**Hennepin County Transportation Department**

**ADDENDUM NO. 1**

**CSAH 153 ; C.P. 041603  
S.P. 27-753-13; SP 141-020-112  
Minn. Proj. TCSP-STP10 09MN(005)**

**BRIDGE VENTILATION SYSTEM – FAN SUPPORT DETAIL**

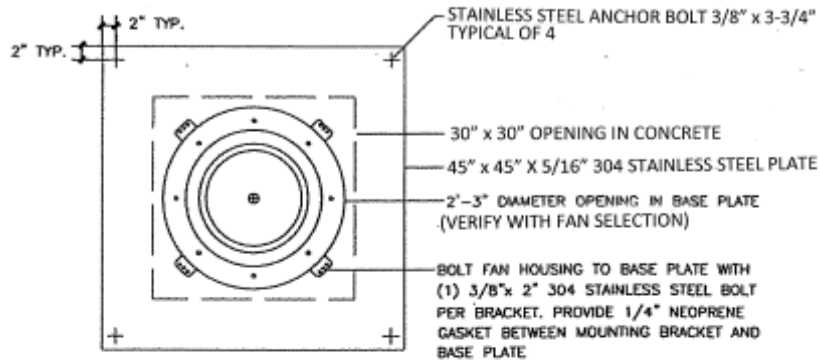
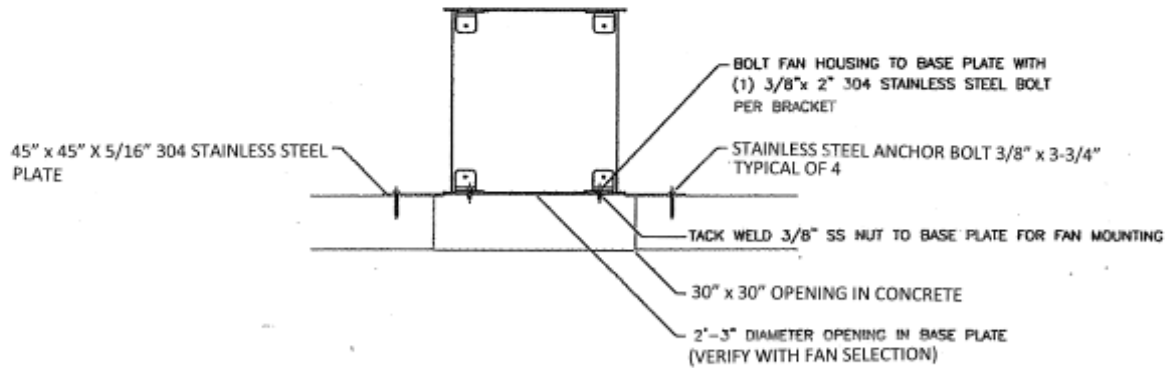
1. Add the attached “Bridge Ventilation System – Fan Support Detail” detail to the Special Provisions. (Detail is referenced in Division “ME”).
